工程指示 / 要求簡箋(E.I.)

工程指示編號：EI / 2605 / 21 修改版次：C

工程編號：J851 工程名稱：青衣明翹匯

工程項目：露台欄河 - 訂購地盤用鐵件 (35/F)

美特鋁質有限公司 MIDI Aluminium Fabricator Ltd.				工程號	J851	類別		物料號	-					
				地盘	青衣190	制圖	W. E. X	2020-10-08	圖號	FR-S01				
修改	+	-	-	採用工廠		地盤	✓	圖紙名稱	铁件加工图	復核	-	-	數量	680+30
日期	19/01	-	-	材料颜色	热浸锌	材料	15mm厚铁巴	批准	-	-	單件重量	2.94	(KG)

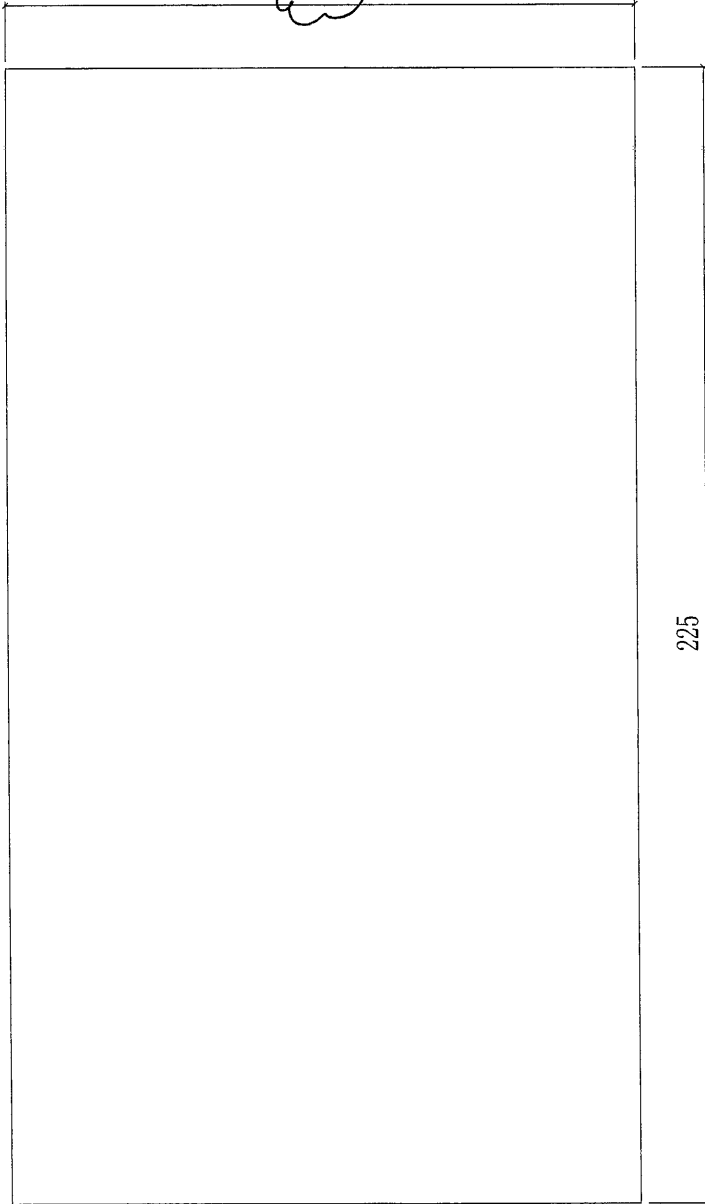
舊圖是150, 現在要改成109

根據 CVI-241 指示，按附件加工圖修改 15mm 厚鐵巴，數量 710 件。
